DESCRIPTION Expansion Dam Detail
PROJECT Sandy River Bridge Proj. No. BH-025-2(46)
LOCATION New Sharon, Me.
DESIGNER Me. D.O.T.
CUSTOMER Callahan Bros., Inc.
JOB NO. 89-670-4
DWG. NO. 22
REV. ②

STATE OF MAINE
DEPARTMENT OF TRANSPORTATION
☒ Approved ☐ Returned for Corrections
AUG 16 1989
☐ Approved as noted ☐ Rejected
K. Jacobs
WELDING ENGR.

DESCRIPTION SPLICE PLTS FOR LINK RETROFIT
PROJECT SANDY RIVER BRIDGE PROJ. No. BH-025-4(26)
LOCATION NEW SHARON, ME
DESIGNER ME DOT
CUSTOMER CALLAHAN BROS.
JOB NO. 89-670-2   DWG. NO. 1   REV. (A)

DESCRIPTION EXPANSION PEDESTALS @ PIER # 3
PROJECT SANDY RIVER BRIDGE BH-025-2(46)
LOCATION NEW SHARON, ME.
DESIGNER ME. D.O.T.
CUSTOMER CALLAHAN BROS., INC.

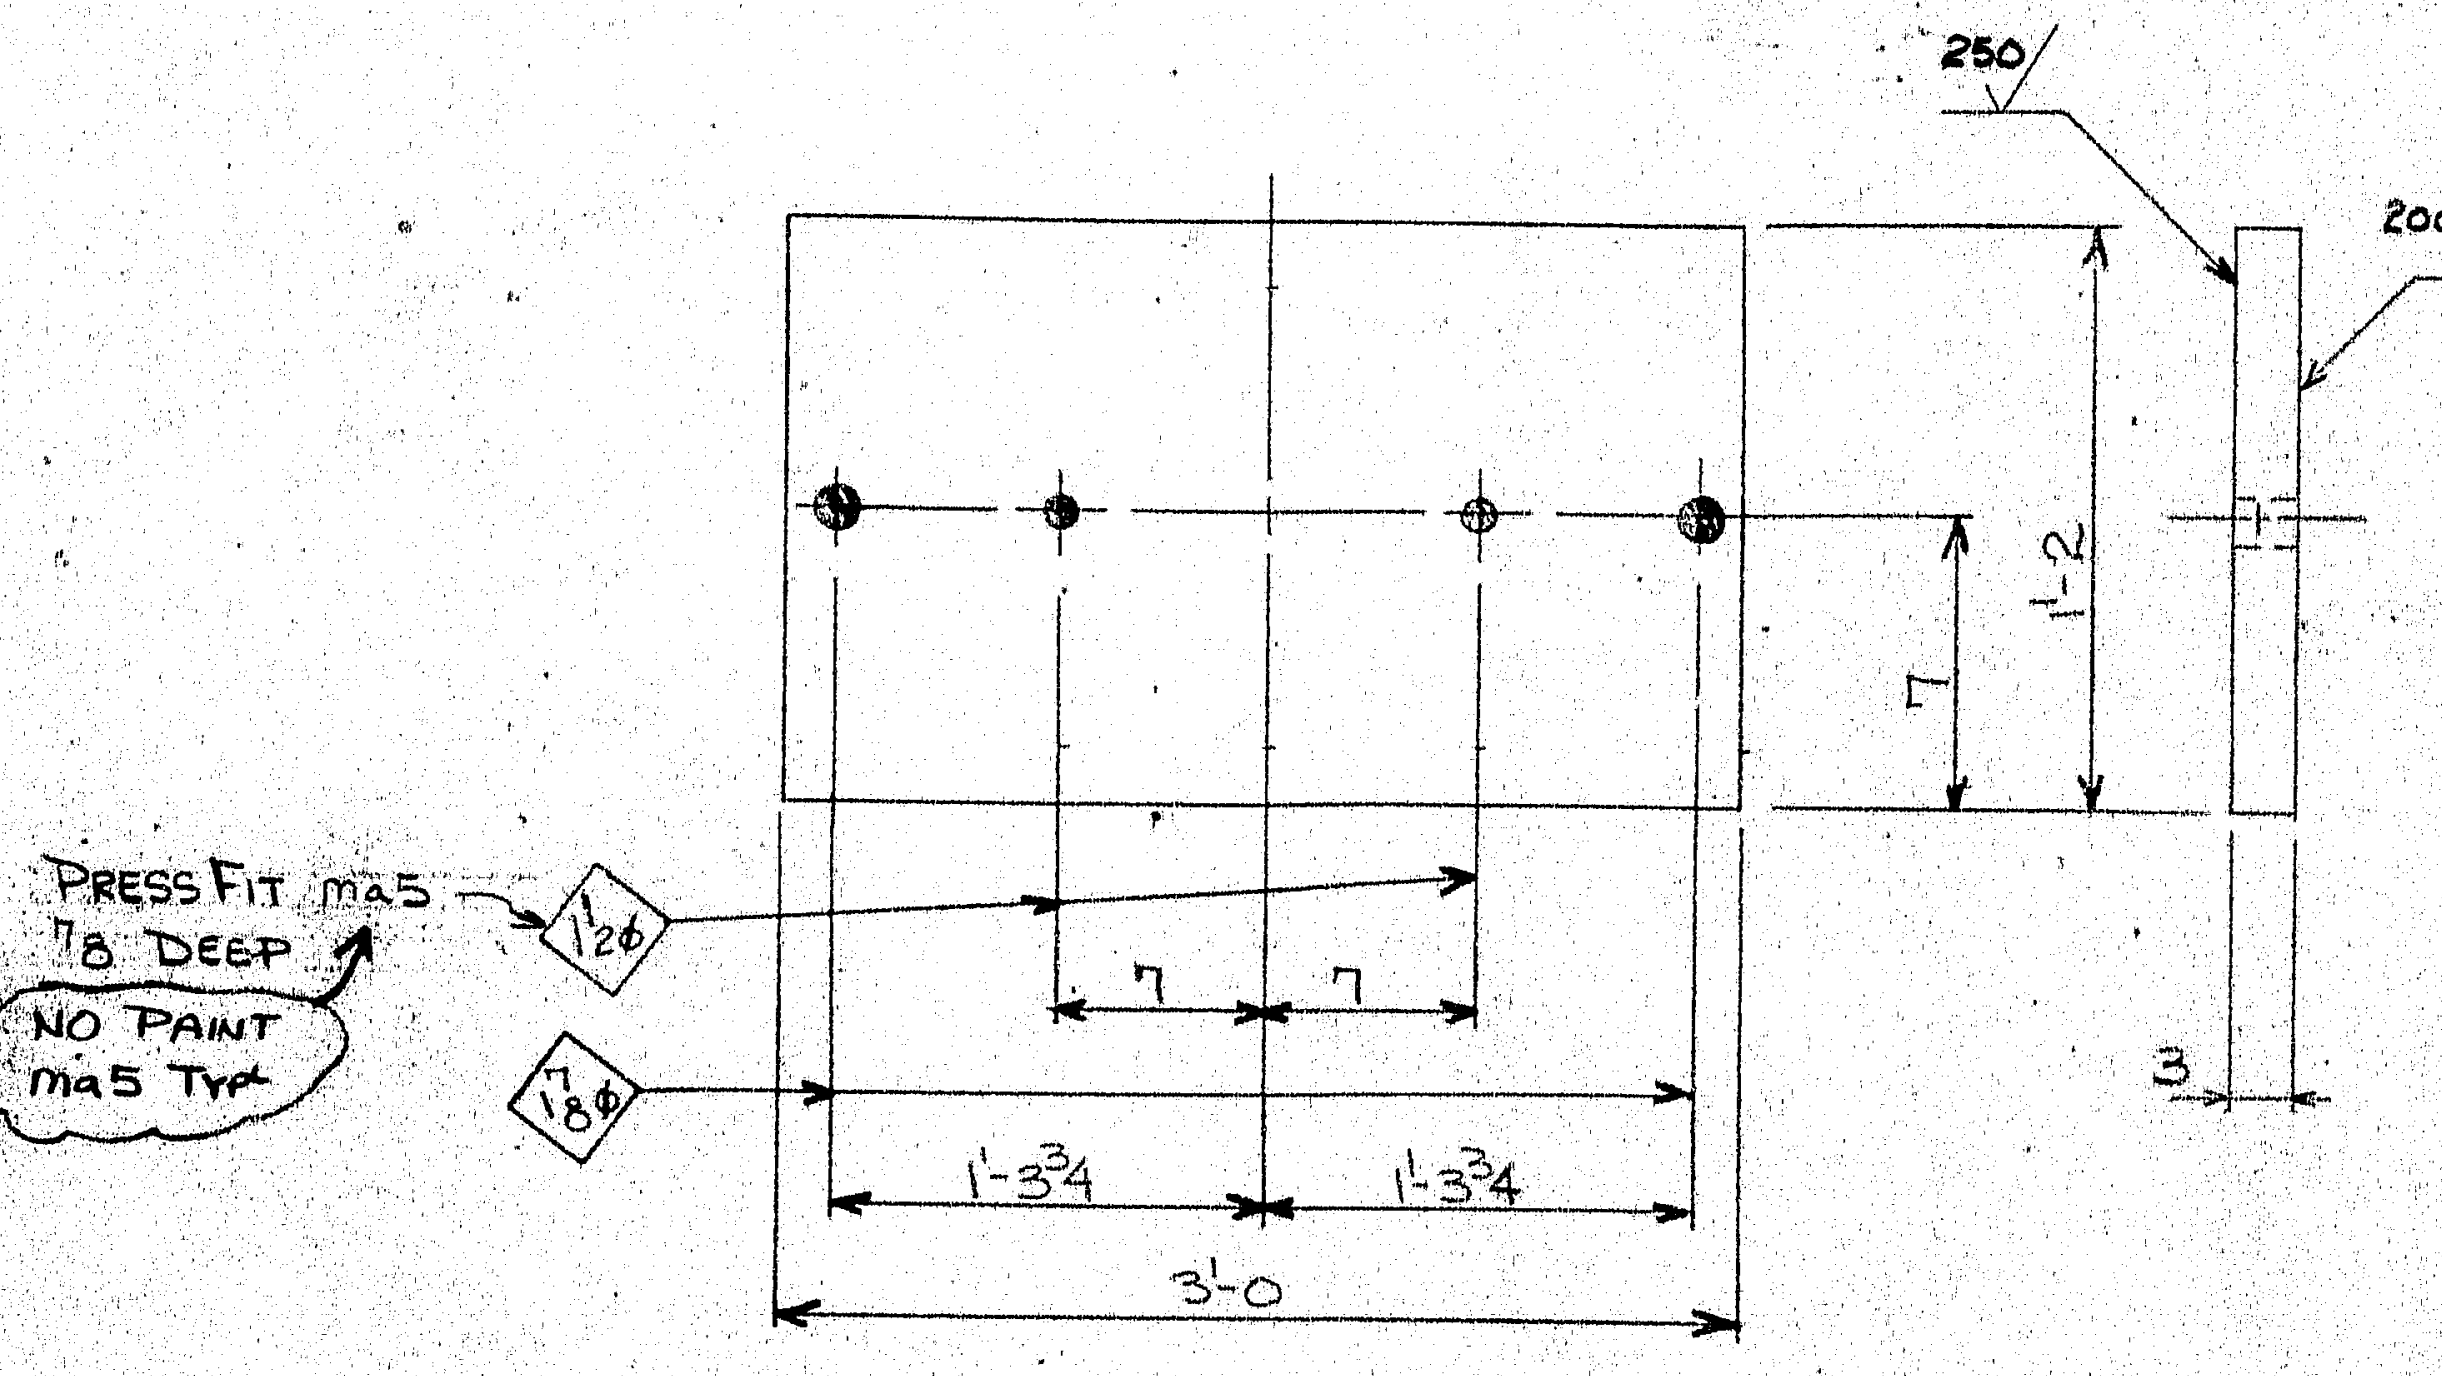
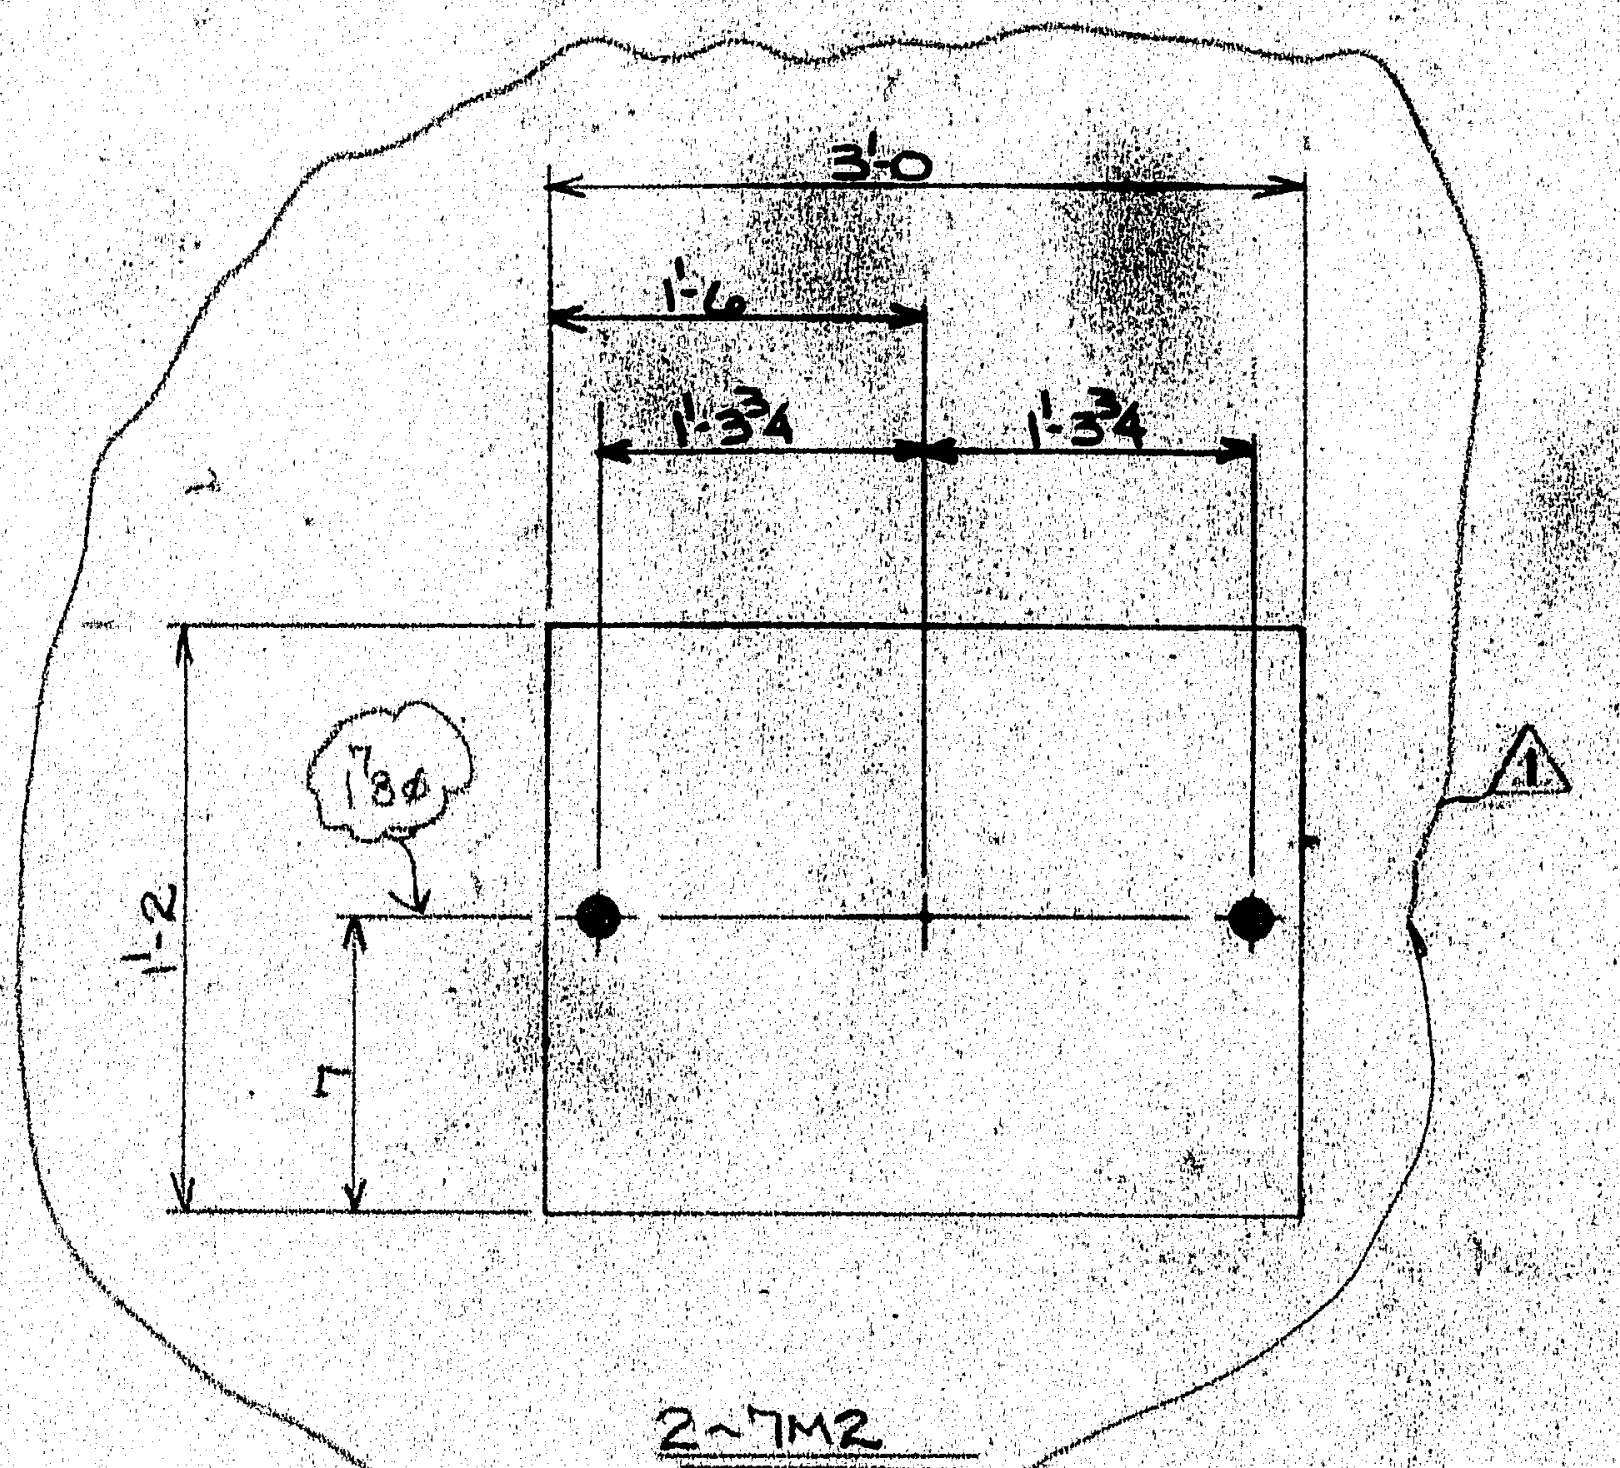
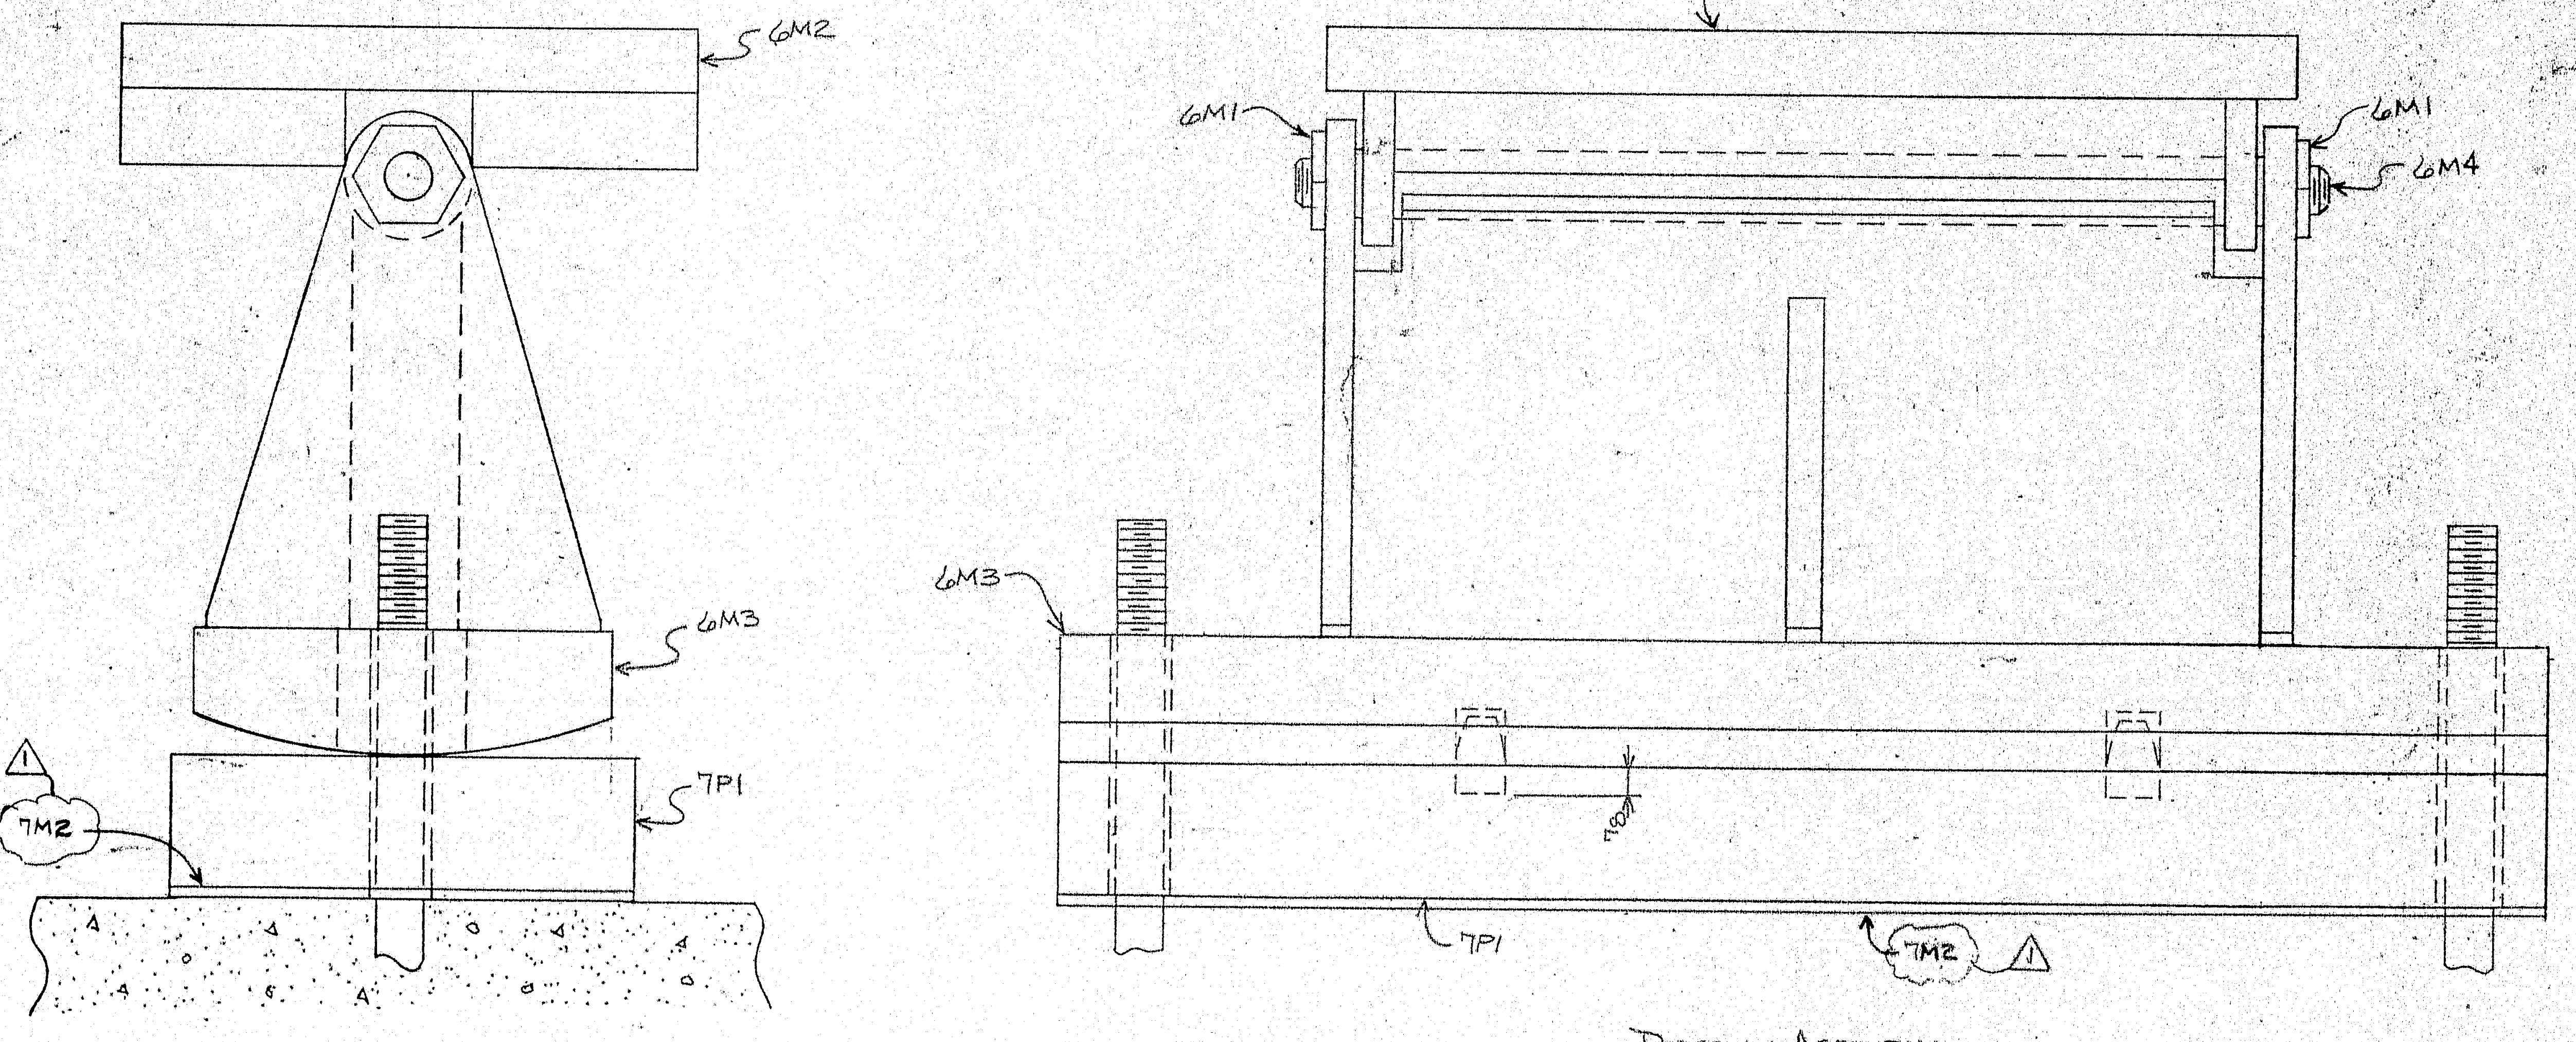
PAINT NOTE: Specification please!!!

2 CHANGED DUROMETER & FROM NEOPRENE TO PREFORMED PADS
1 REVISED PER APPROVAL PRINT
